SUBMISSION OF DETAILS FOR THE DISCHARGE OF CONDITIONS

APPLICATION REF: DM/22/2218

At Maxwellton House, Boltro Road, Haywards Heath

CONDITIONS: 6 Materials, 7 Elevation Details, 8 Details, 17 Cycle Store, 18 Solar

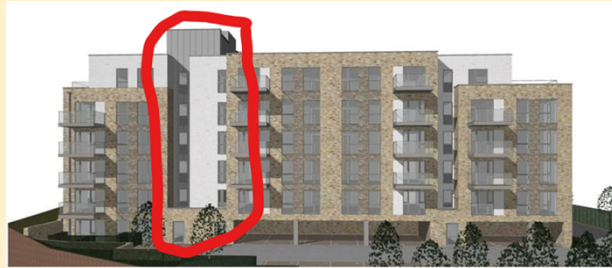
PVC should have a separate Code, please correct it and annotate accordingly. E1 AND E2 are not explained; louvers and balcony railings should be supported with an illustration in the key and spec should be provided for an approval. Also, annotate clearly all balcony PPC aluminium profile flashing on drawing 0401 Proposed Elevations 01 02 and dwg 0401 Proposed Elevations 03 04 – the annotations seem to be in conflict with dwg 0250 showing balcony stacks; if there is any powder coating applied provide RAL colour in the description. Need an updated material schedule as per dwg 0401 as materials specified in that differ from Material Schedule.

2. In addition, these elevations show a plethora of external vents which were not shown in the originally approved elevations. I can only assume this is related to a lack of suitable solutions for ventilation overall. Please provide plans and sections covering the ventilation requirements to help us understand the changes. Please note this will, however, need separate approval through Building Regulations. As presented, this would have a domino effect on how the elevations look, and the standard of the units within the building which I cover in other points. This vents are an essential element of the sustainability strategy. The vents provide the intake and outtake requirements for the mechanical ventilation heat recovery system. A colour match vent has been included on the details section of the plan attached and the location of these vents has been regularised in the latest detail. My comment: Explain why some vents are hidden behind the RWDP? My previous request remains unchanged, provide details, plans etc of the mentioned mechanical heat recovery system for an approval by Building Regs Section. However, the introduction of individual units would change the aesthetics of the building which was not considered as part of the original permission where it was assumed that one plant/system would be used for the whole building and placed on the roof / within a plant room. Is there not one whole system still being provided as the individual vents give the appearance of individual systems for each flat. The additional of vents in the external appearance would change the approved elevations and this would need to be considered as a new application.

LSE-2780-04-A2118_Balcony Stack
A - details pg.1

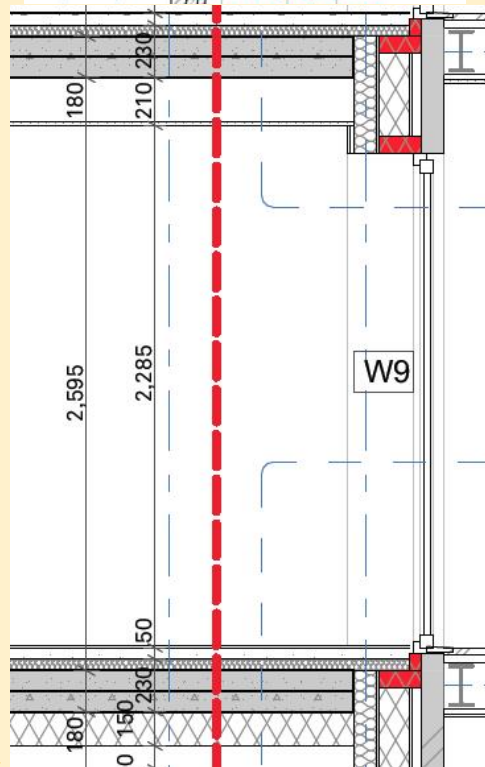
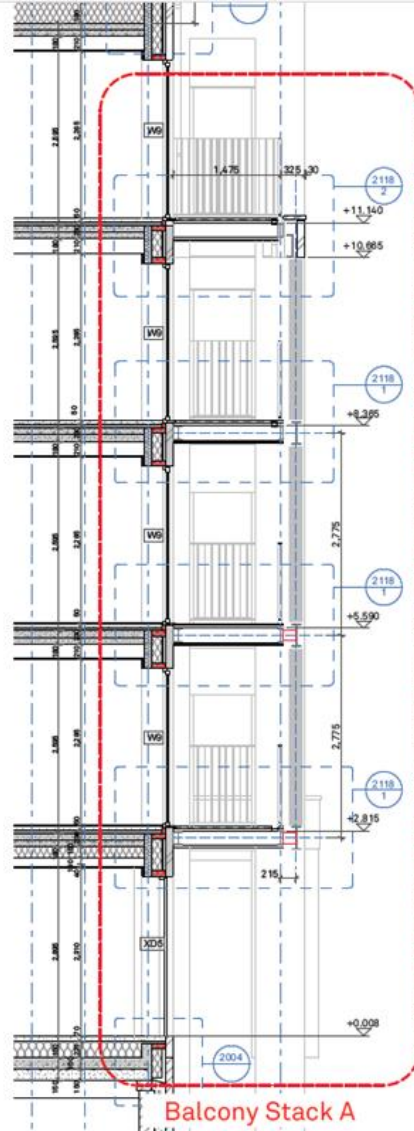
1. Section showing lowered ceilings resulting in floor to ceiling height of 2285mm – explain how this corresponds with the Building Regs. Ceiling height has not changed from planning stage. This is the same height applied to all McCarthy Stone developments an no issue with Building regs See below approved section showing floor to ceiling dimensions as minimum 2,775mm (dwg: Proposed Sections SS-06 and SS-10 - approved drwg 0301 Rev P05)

- 1.
2. Balcony railings details provided are not as per approved and this should be glazed balustrades. Have needed to revert to glazed balustrade. The primary reason for this has been associated with fire safety and maintenance. Approved planning drawings have very slim line light weight

3. Drainage system to the balconies is not shown. More details needed to establish how water is drained from balconies to prevent dripping of water to balconies on lower level. We would expect the water from balconies to be redirected to rainwater pipes hidden in the brick columns. All are positively drained – behind each brick post there is a drainpipe for drainage of balconies. **Acceptable**

4. Ceiling of the balcony is not acceptable and has to match SVK Fibre Cement cladding used for the ceiling showed in dwg: *LSE-2780-04-A2205_Typical 5th Floor Balcony Overhang in Brickwork* . Annotate colours in RAL. Drawing 2118 – to be updated to specify this product. Previously not confirmed. **Not received yet.**

5. Flashing/cover to the steel frame is missing and should be applied as shown on approved elevations. Provide details. Steel details to be confirmed – approved elevations shows exposed steel. **Can you confirm where/which approved plans, drawings, elevations; provide reference numbers**
